District Office- Tenant Improvement

981 Ridder Park Drive, San Jose, CA 95131
MDG Project # 2203

MECHANICAL UPGRADES – BID #B-03-2022-23
ELECTRICAL UPGRADES – BID #B-04-2022-23
GENERAL CONSTRUCTION – BID #B-05-2022-23

October 21, 2022

Drawing Number
A-8.2

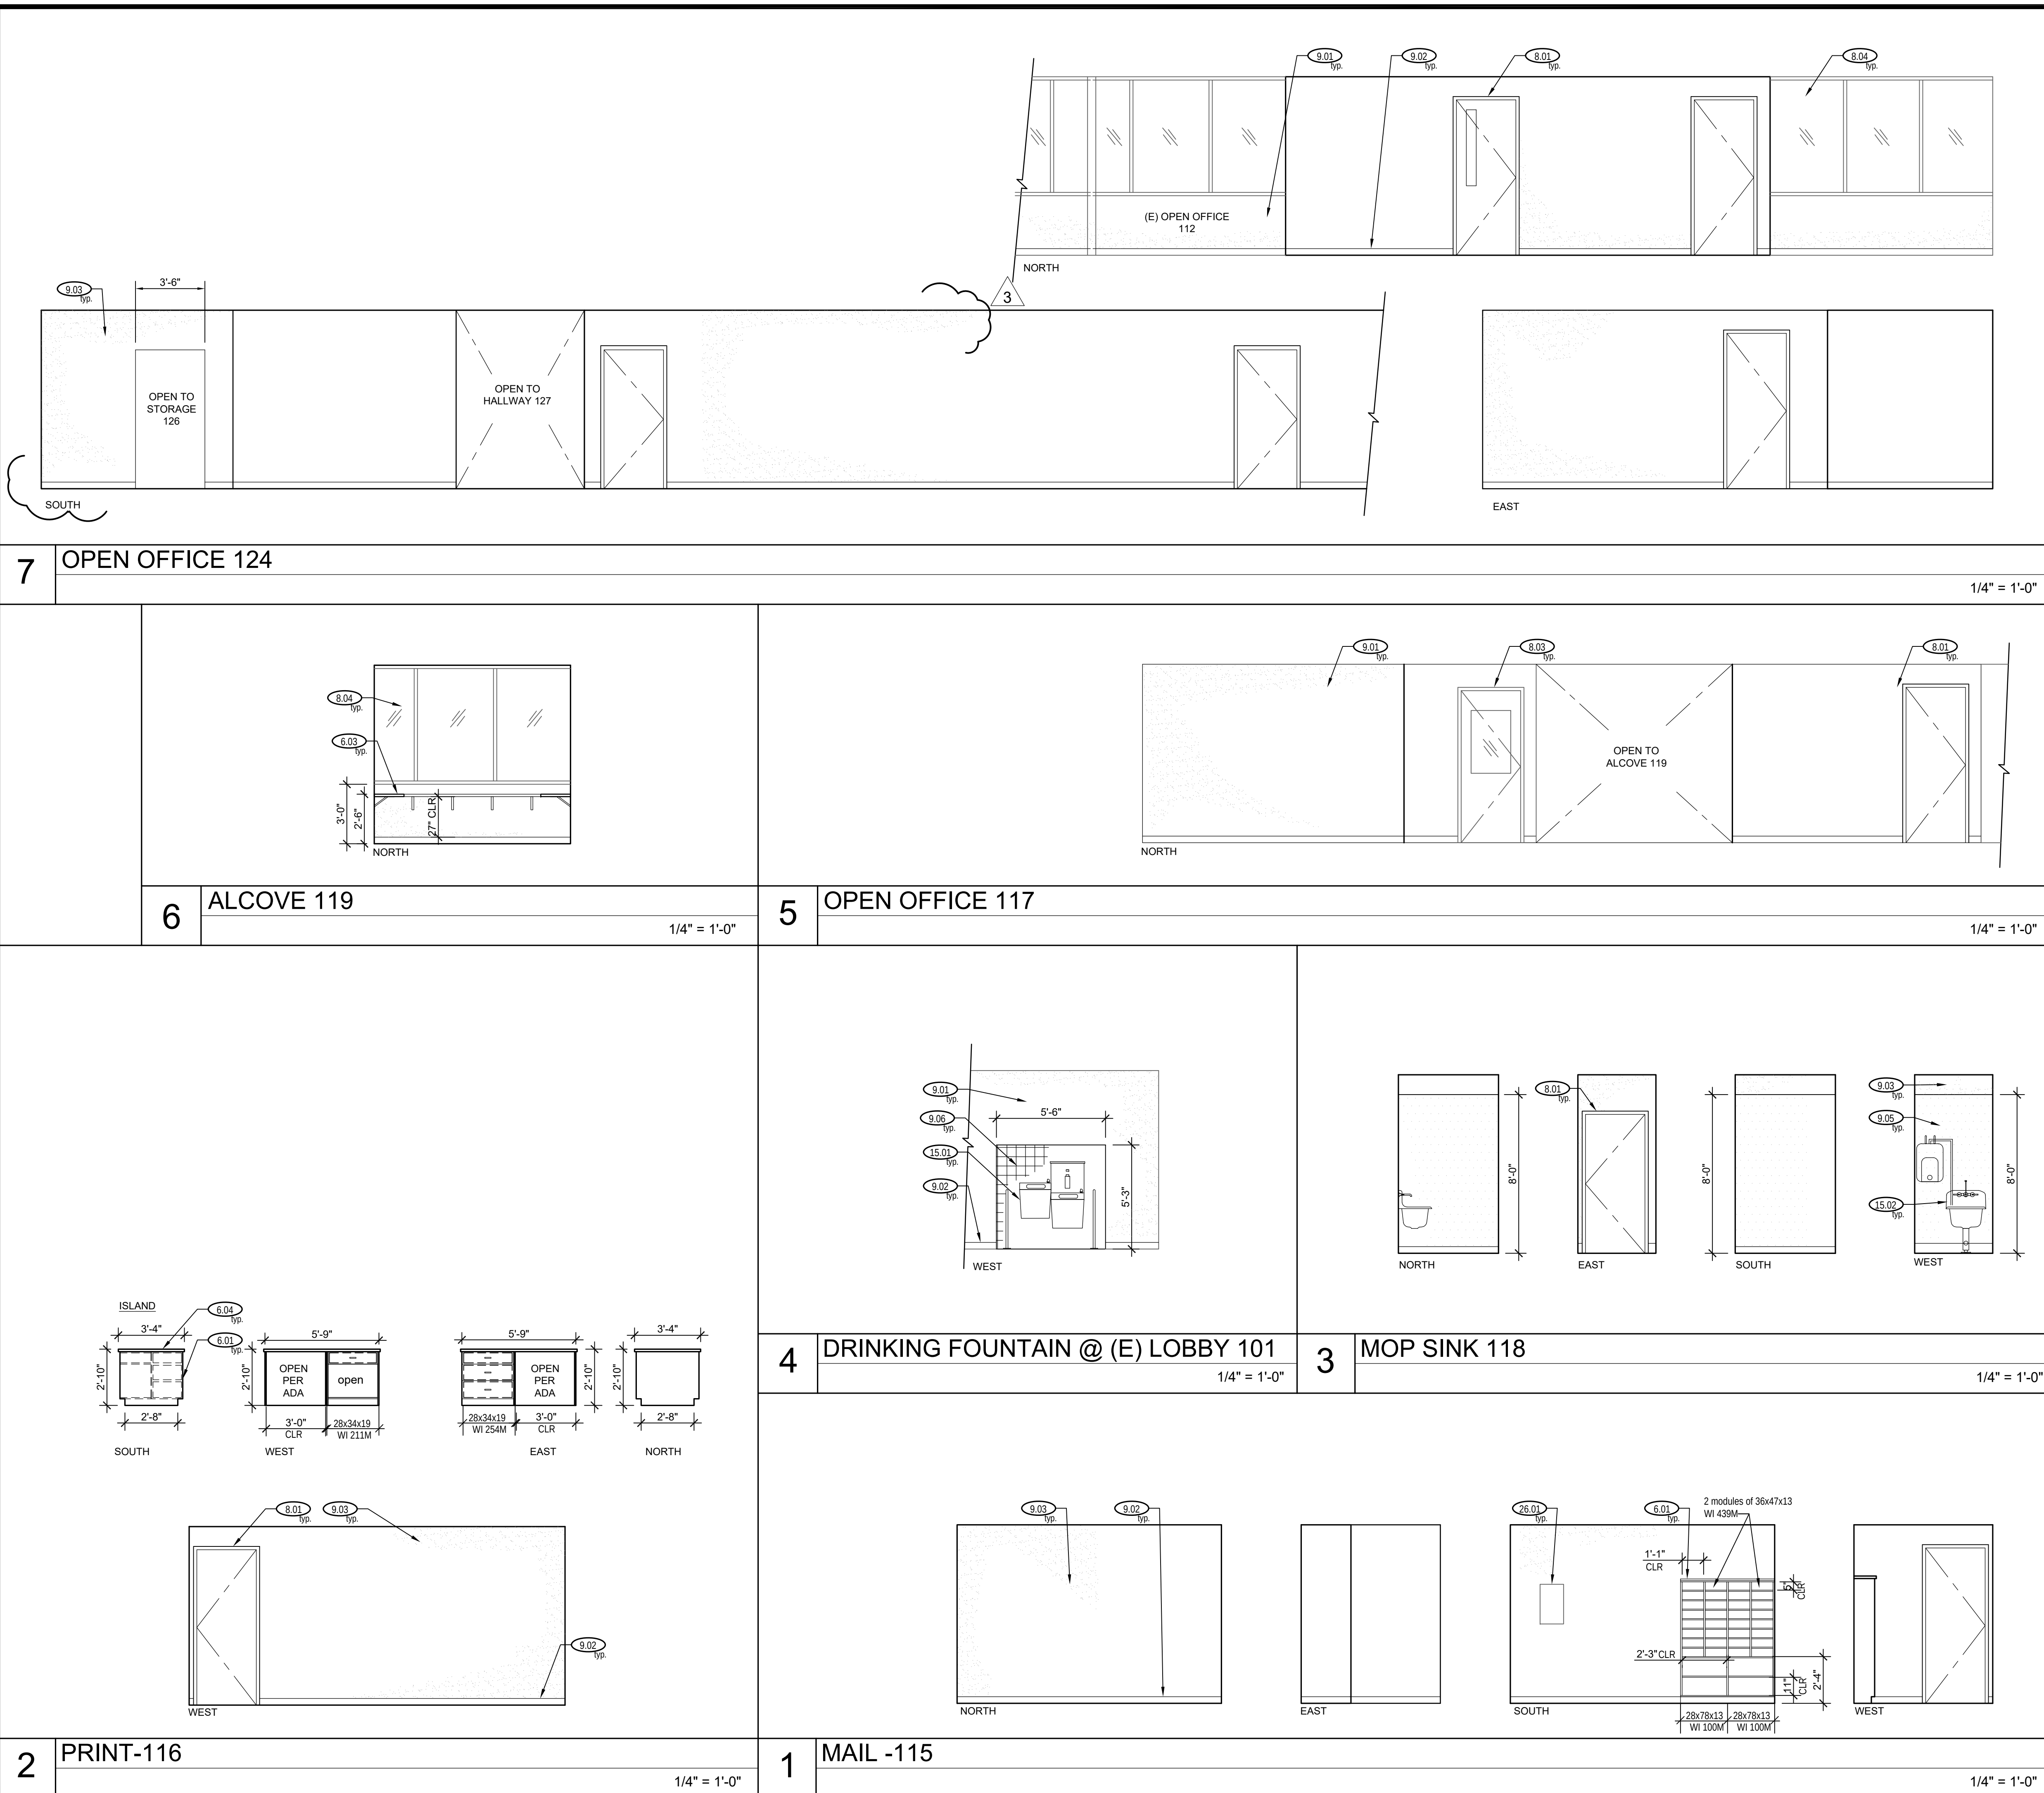
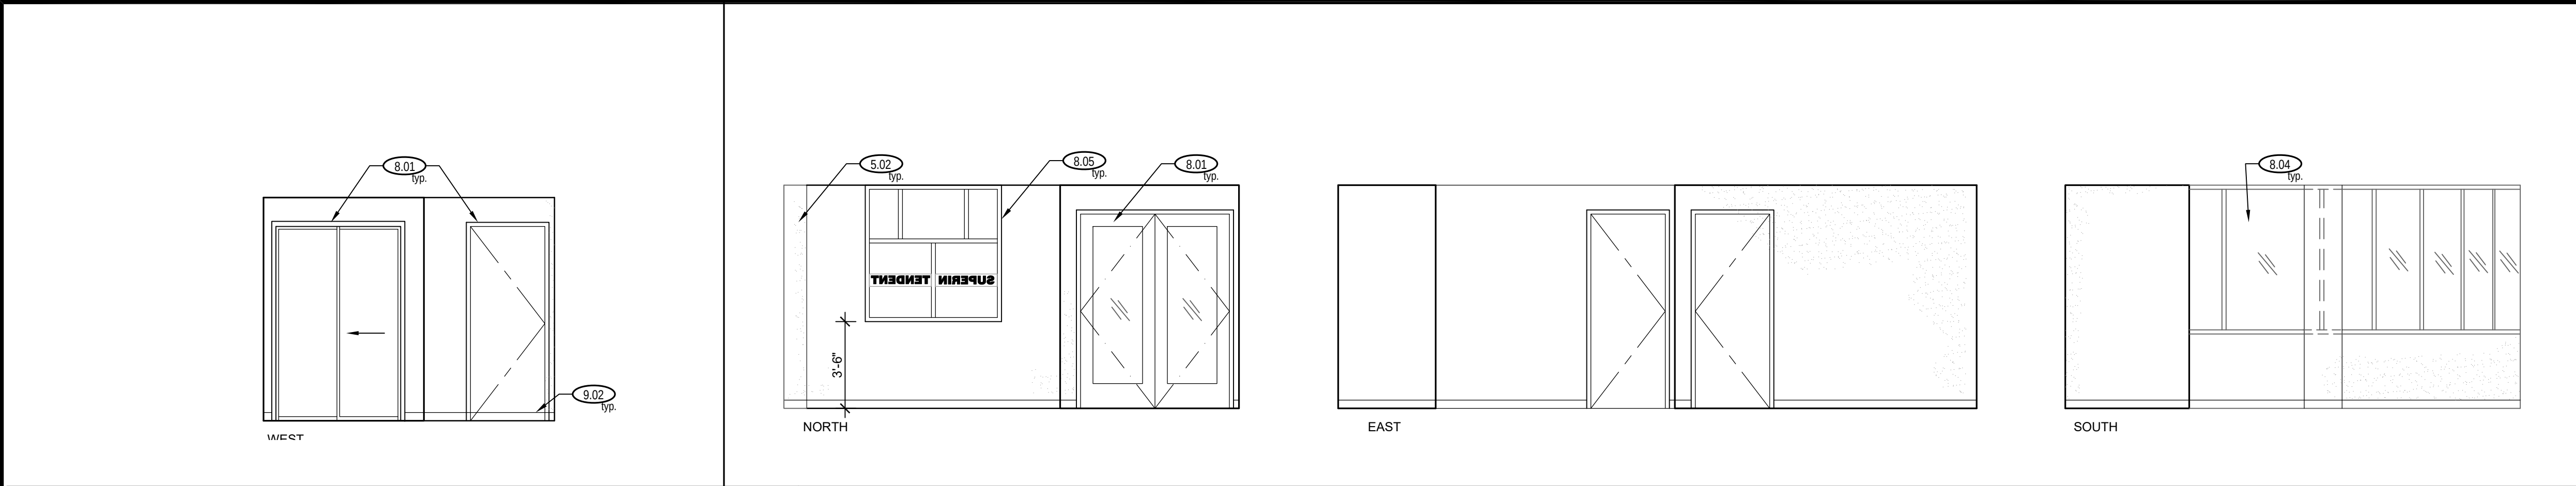
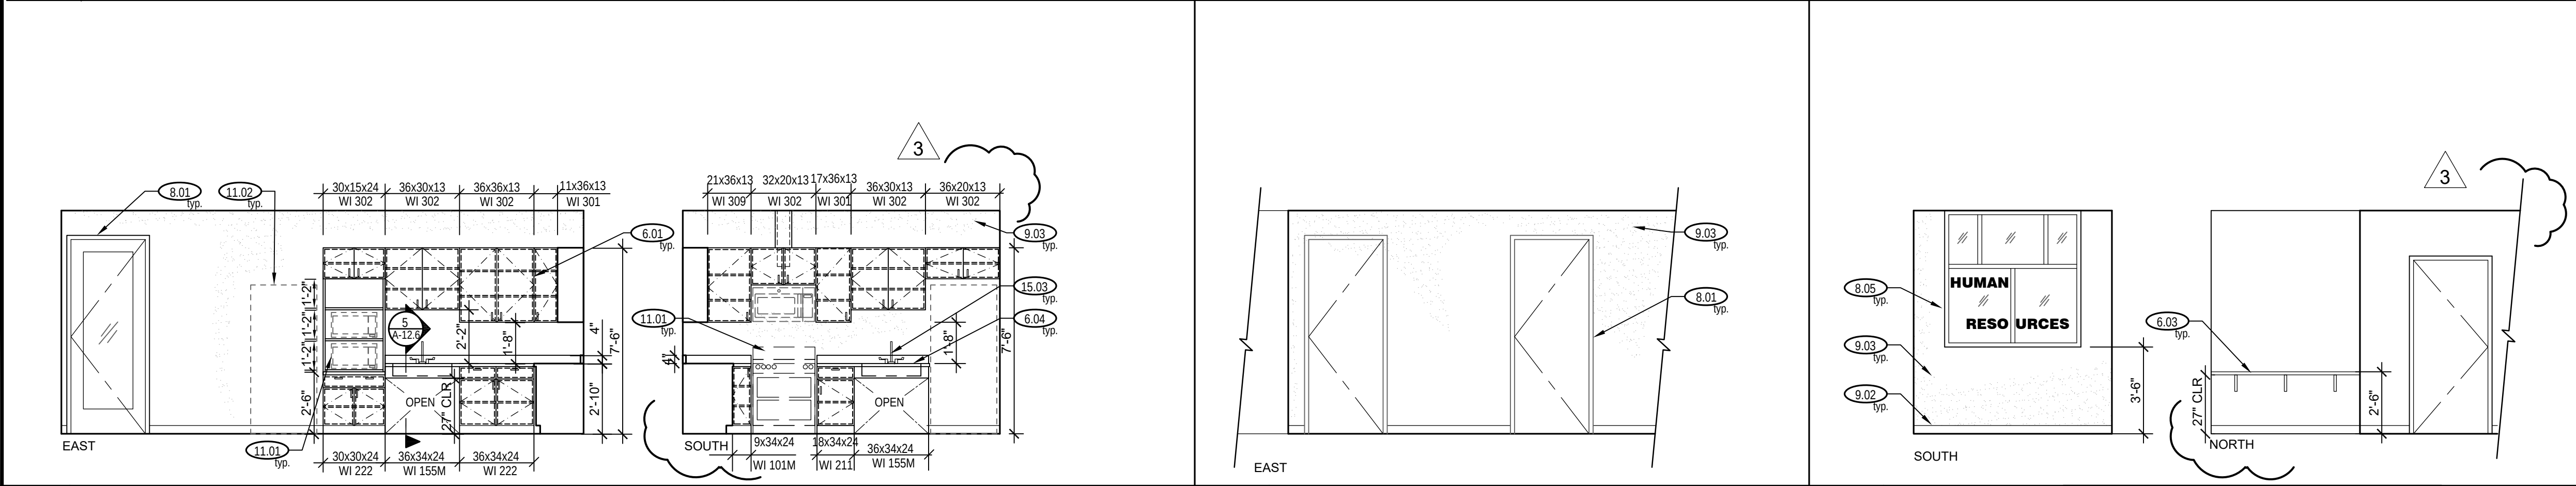
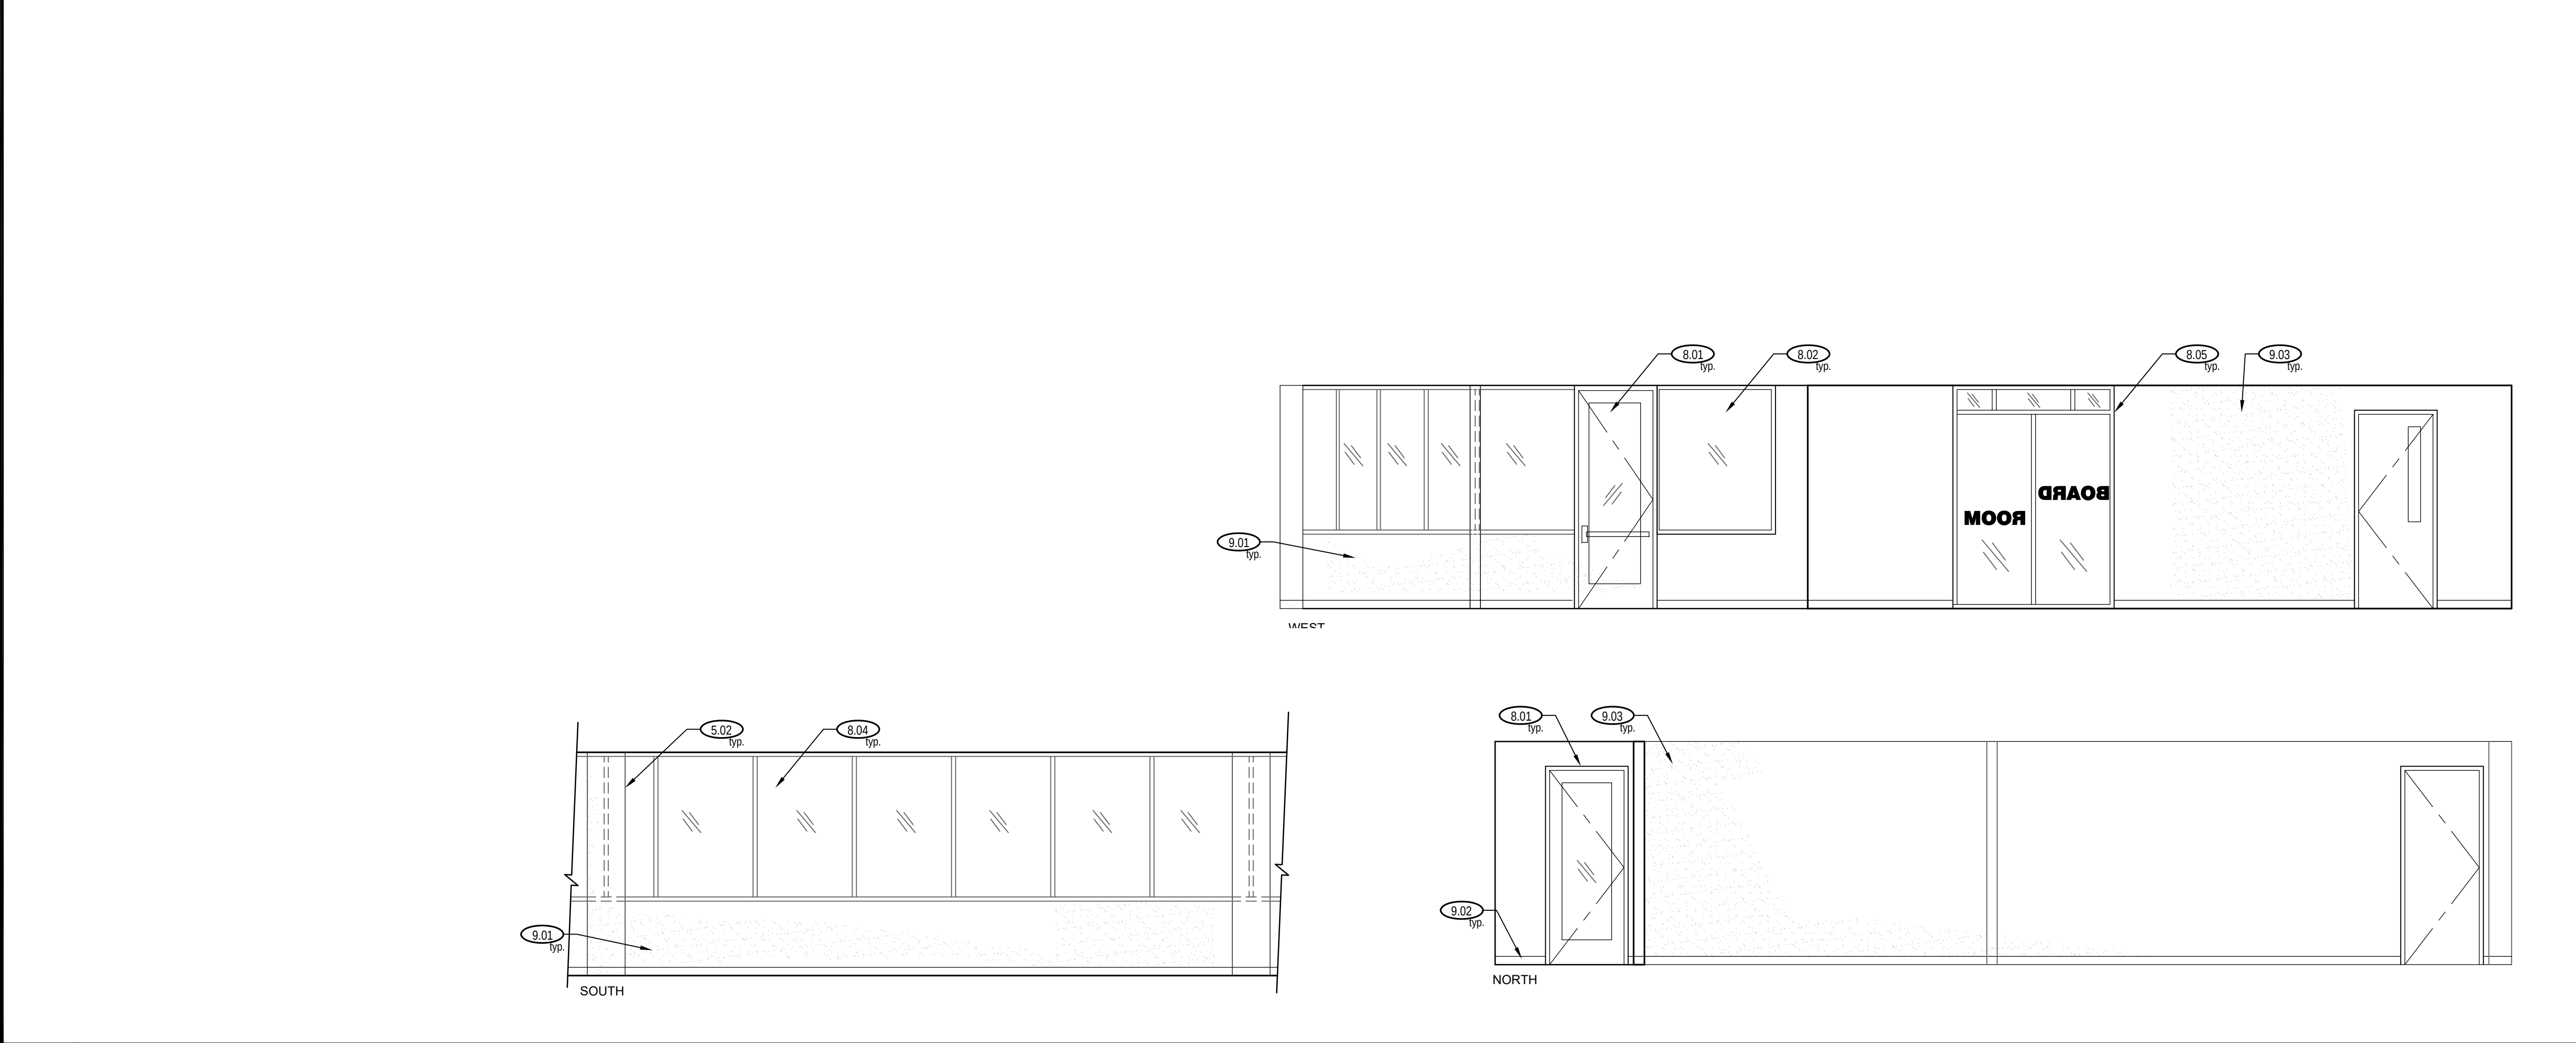
Item 10: Sheet 8.2 Interior Elevations

- A. See revised 7/A-8.2 South Elevation to reflect a wider opening at Storage 126 and adjusted door location at Storage 120.
